## MEMORANDUM

**RE: REVIEW OF WEKIVA RIVER HYDROLOGY AND HYDRAULIC MODELING**

This technical memorandum summarizes INTERA's review of the Wekiva River HEC-RAS and HSPF models including the following documentation:

- *Wekiva River Hydrology and Hydraulic Modeling for Minimum Flow and Level Evaluations (Seong and Wester, 2018)*

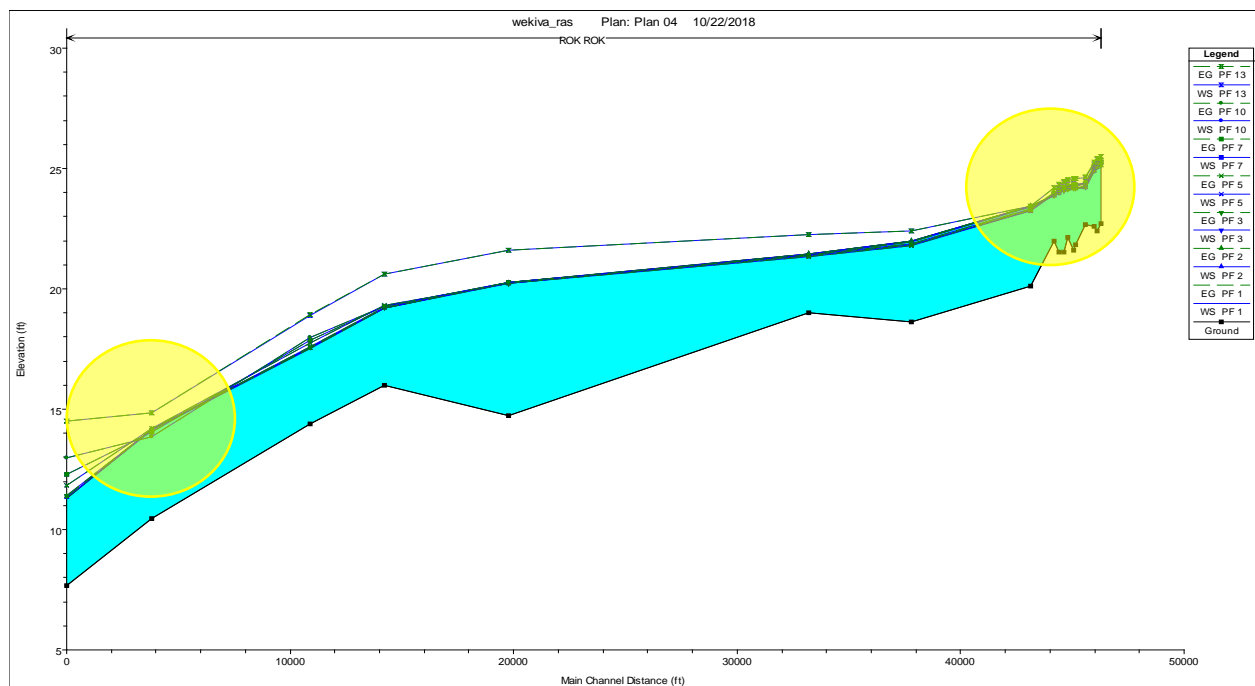
Flow and stage plots were examined as appropriate in both models to look for modeling instabilities. No model instabilities were noted in the HSPF model. Slight instabilities were noted in the HEC-RAS model as it relates to the simulated stages. As shown, stages are expected to increase as percentile flows increase. There are instances where the flow profiles for various percentile flows intersect each other. Upon further examination of the flow profiles, it was noted that this is due to inconsistencies in the flow profiles based on the observed data. For example, the flow at ROK4 for PF 12 is 72.5 cubic feet per second (cfs), while the flow at ROK4 for PF11 is 79.5 cfs. The corresponding flows downstream at XS2 are 992.4 cfs and 896.8 cfs. While this is to be expected since it is a steady-state model with flow profiles based on observed data, it may be helpful to smooth the flow profiles so that inconsistencies are not simulated (e.g. a higher stage at a lower flow profile).

Figure 2. Cross Section Example

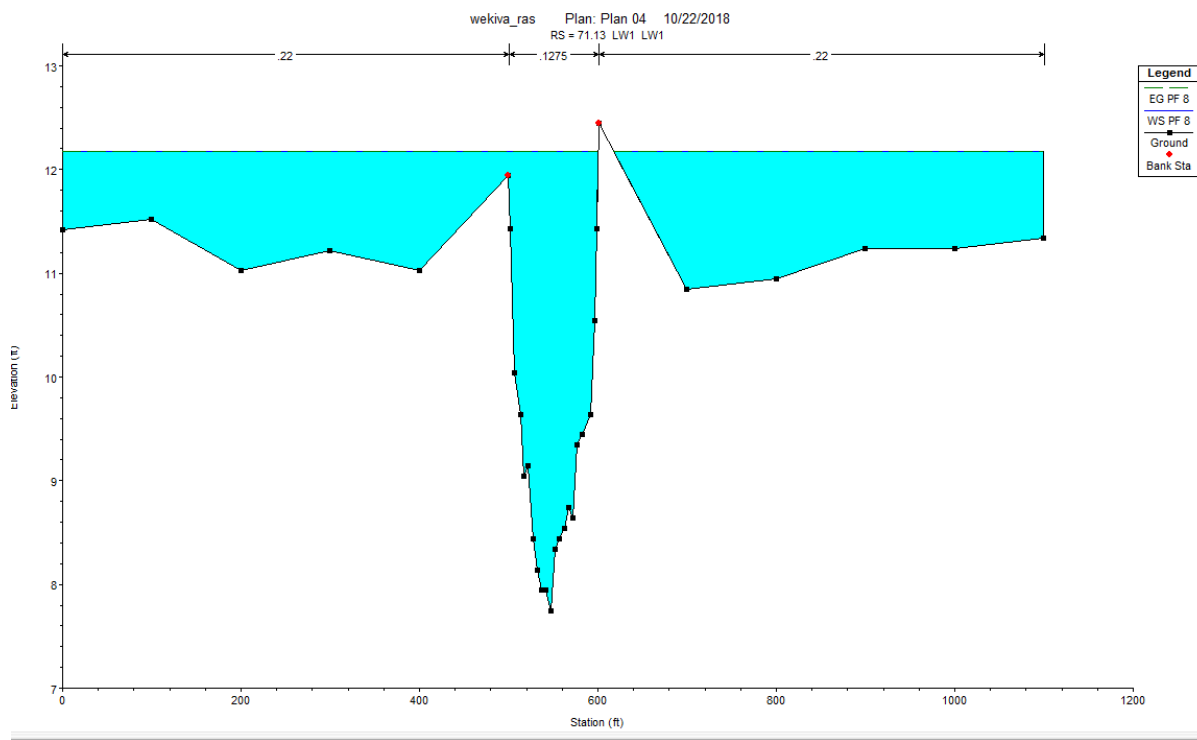
There were no warning or error messages present in the HSPF model. There were several warnings noted in the HEC-RAS simulation related to the potential need for additional cross sections due to the conveyance ratio being outside of the expected range. Additional cross sections could be added if desired, but this should minimally affect the overall model performance. Several errors were noted for cross sections that needed to be extended for the computed water surface, as shown in the example cross section below. These cross sections should be extended so that the water surface is fully contained within the cross-

sectional area. Although this should only minimally affect results, it is good modeling practice.
